**ADDENDUM
NO. 4**

October 9, 2024

**LOWELL HIGH SCHOOL NATATORIUM ADDITION
AND RELATED WORK**

ADDENDUM FOUR

SHEET
A S-205

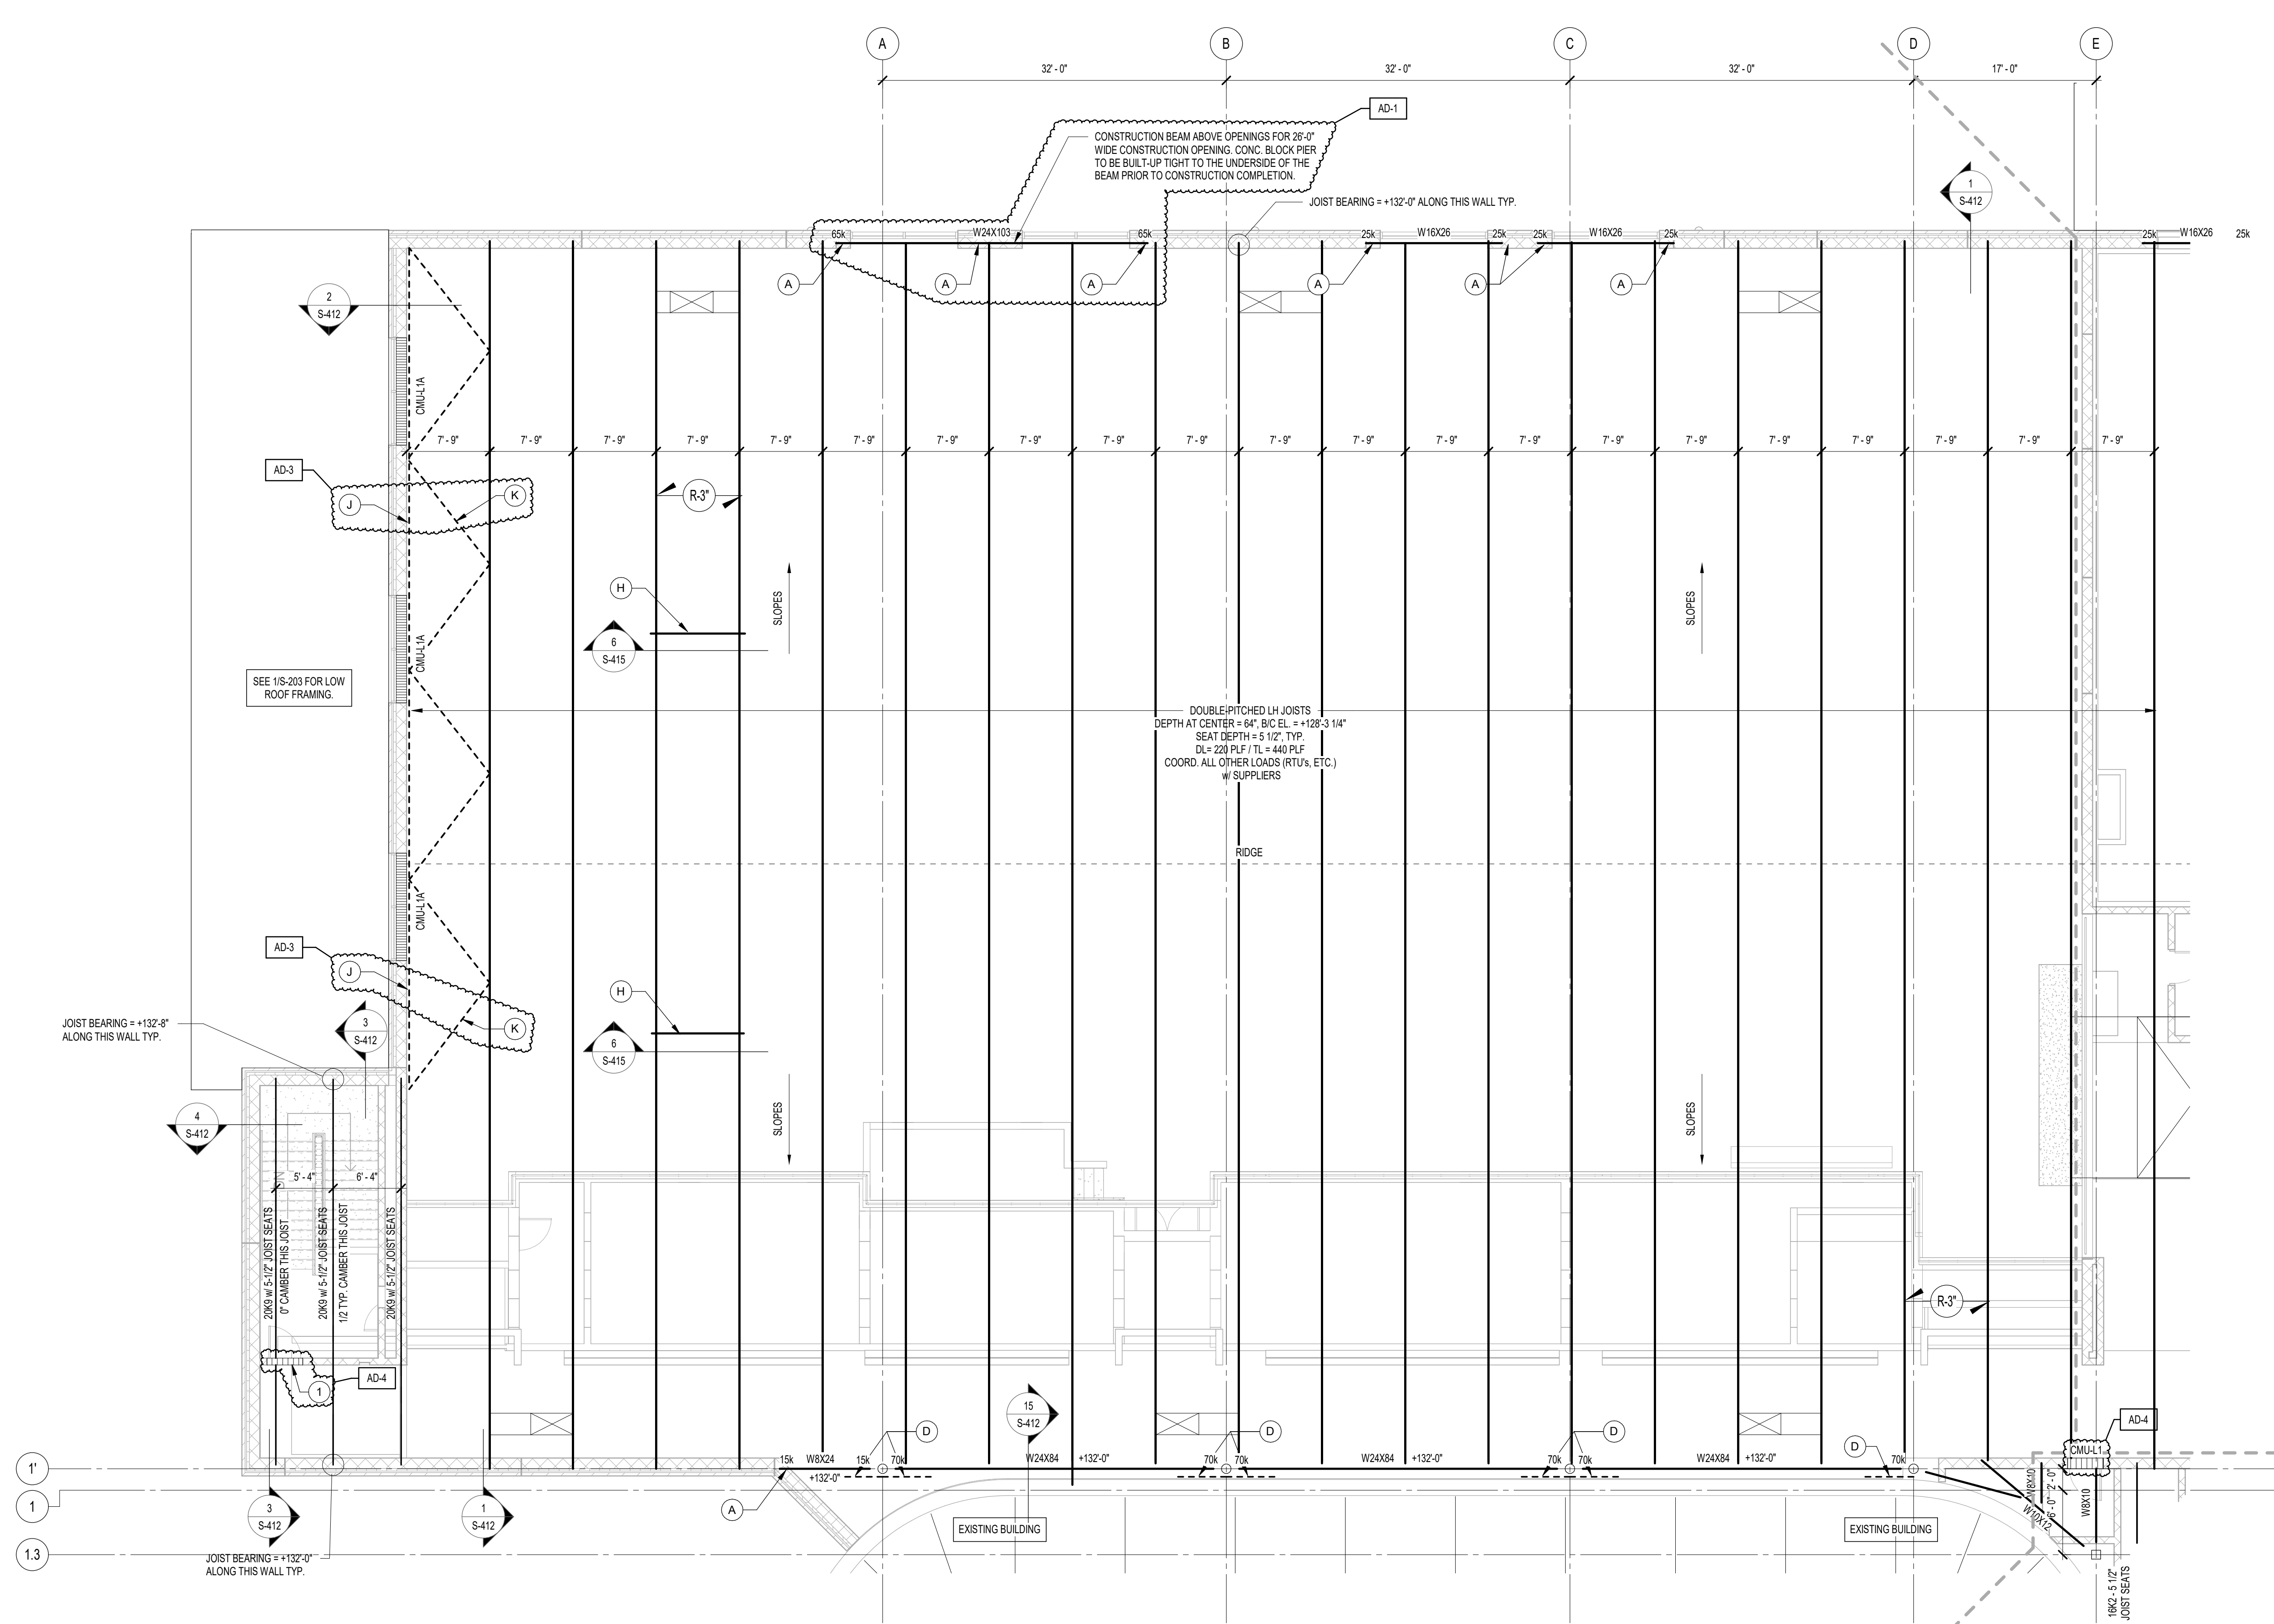
- 3. Sheet S-205**
 - A. Refer to revised full size sheet included in this addendum for the following revisions.
 1. Roof Framing Keyed Notes
 - a. Keynote A – Clarification Added for Beam/Lintel Bearing.

2. CMU Lintel Callouts Added.

SHEET
M-301

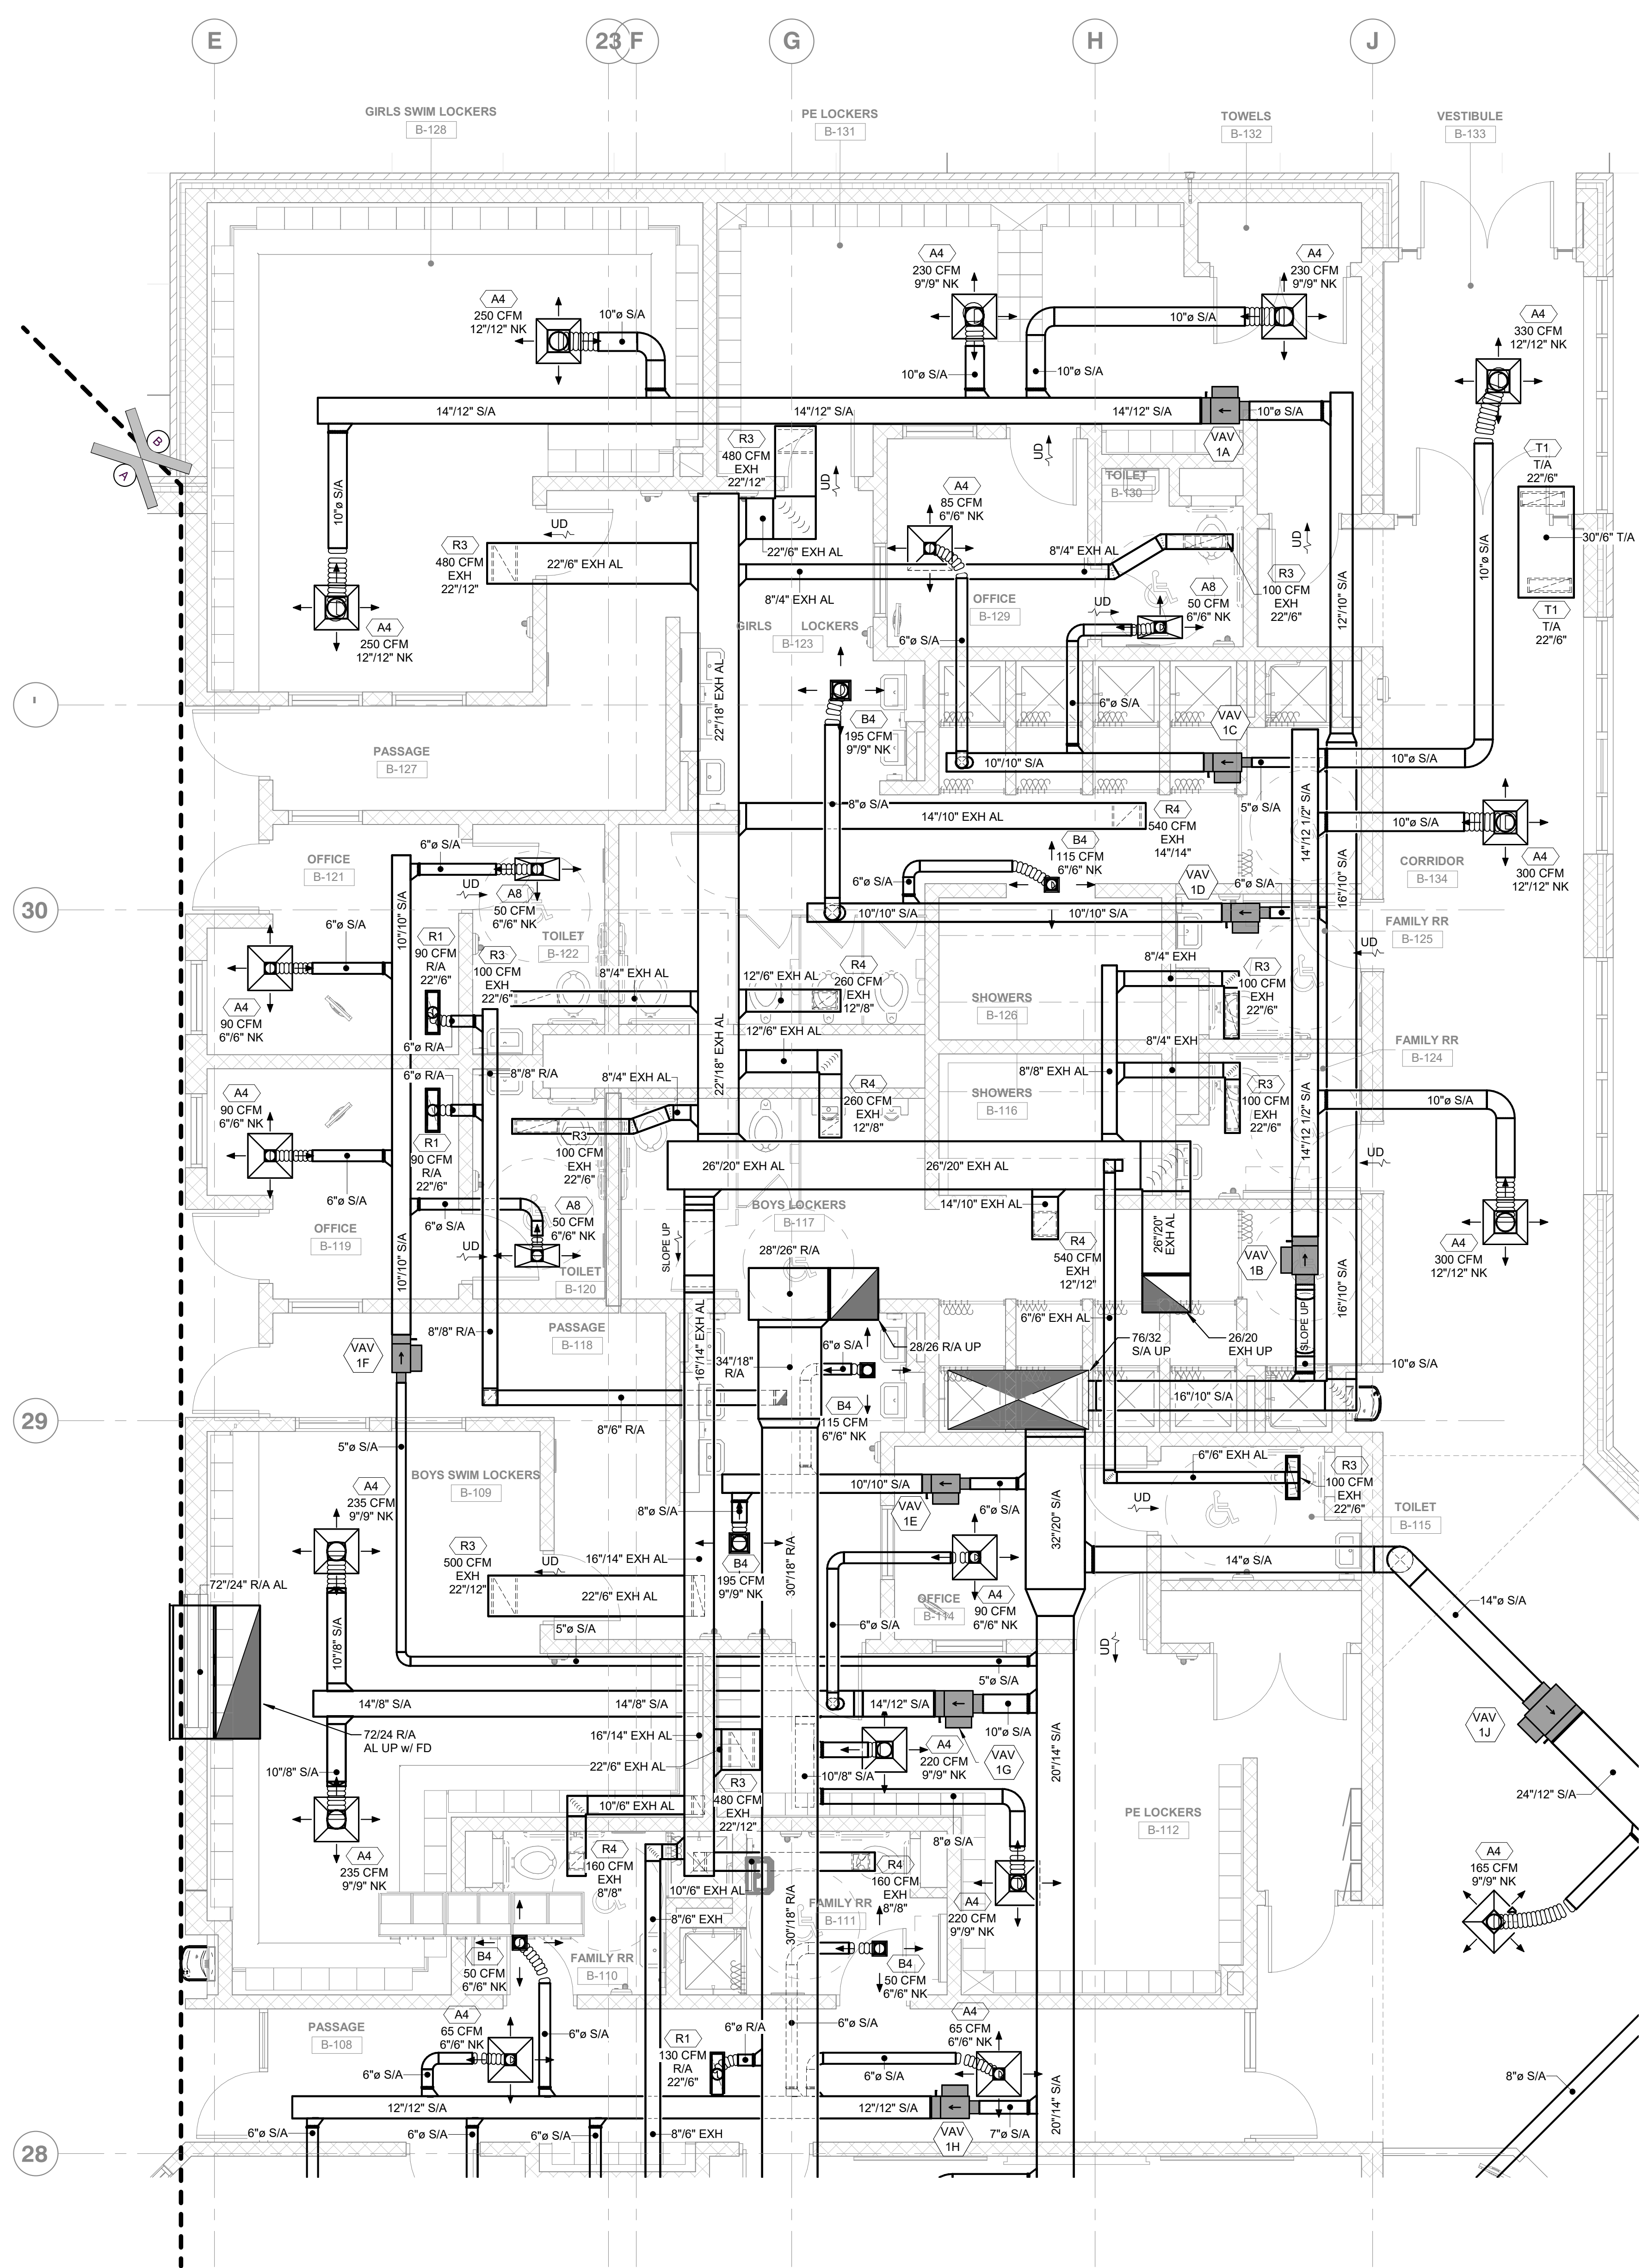
4. Sheet M-301

- A. Refer to revised full size sheet included in this addendum for the following revisions.
 - 1. Adjusted louver location, size, and associated ductwork to match architect's location.
